New Media Filter Series 4000A

ODIS wishes to inform you of the engineering changes implemented in the media filters series 4000 in models 30", 36", 48" and 60". Changes were made to improve and optimize the operation of the filters and enable easy, quick and simple installation of arrays with modular units installed on skids. Due to these changes the names of the improved models were changed.

Single filter mounted on skid

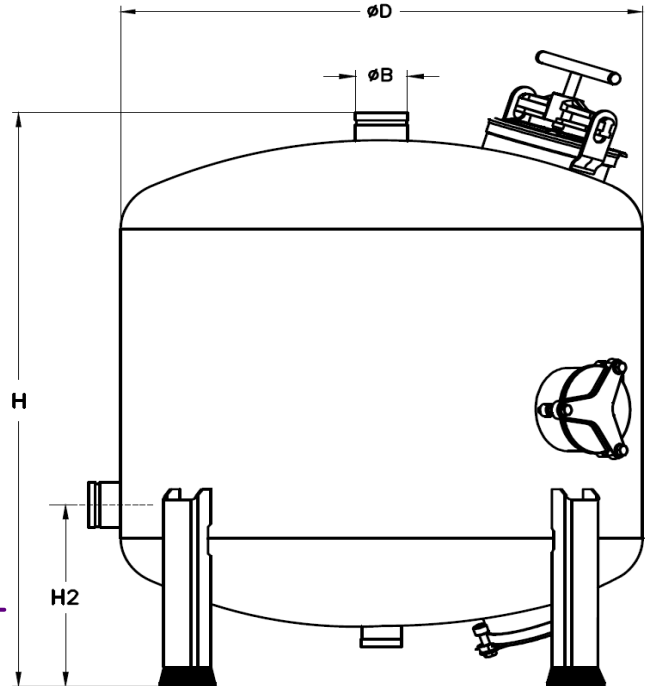
- Increased volume of the filtration area (increased filtration depth) and increased media quantity.
- Change in the position of the filtered water outlet.
- Changing the filter's legs, including an option for installation on a designated skid.
- The improved models allow for skid-mounted filters as individual modular unit (one filter) and double modular unit (two filters) for assembling a complete array flexibly and easily; as well as simplicity in modification and future extension of arrays.
- The new model numbers: 4303A ,4363A ,4484A ,4604A

Dimensions of New Version

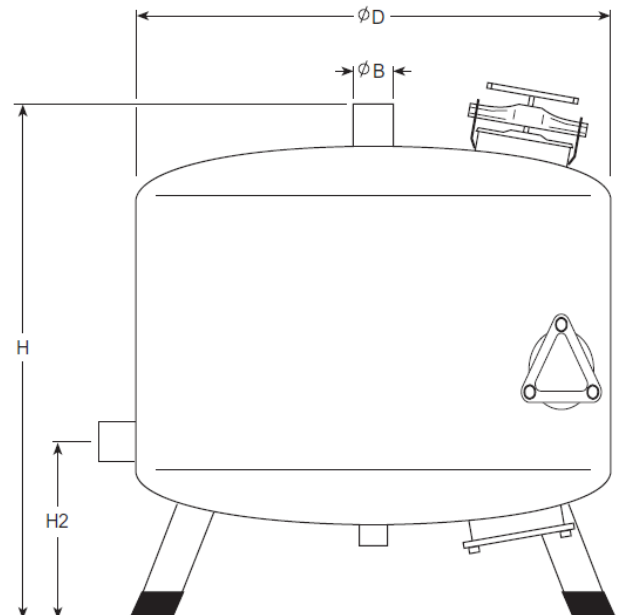
- Shipping of individual filters (not skid-mounted) will be carried out as before (pair of filters installed one on each other). Following the change, filters can be shipped in pairs only in HIGH CUBE containers.
- Installation dimensions are different than the previous models' (It is not possible to install two types of old and new filters in the same system).
- Previous models are available to customers who wish to order the previous version.
- The prices of the new version will remain the same as the previous version.

Note: Dimensions H and H2 vary in the case of filters installed on skids.
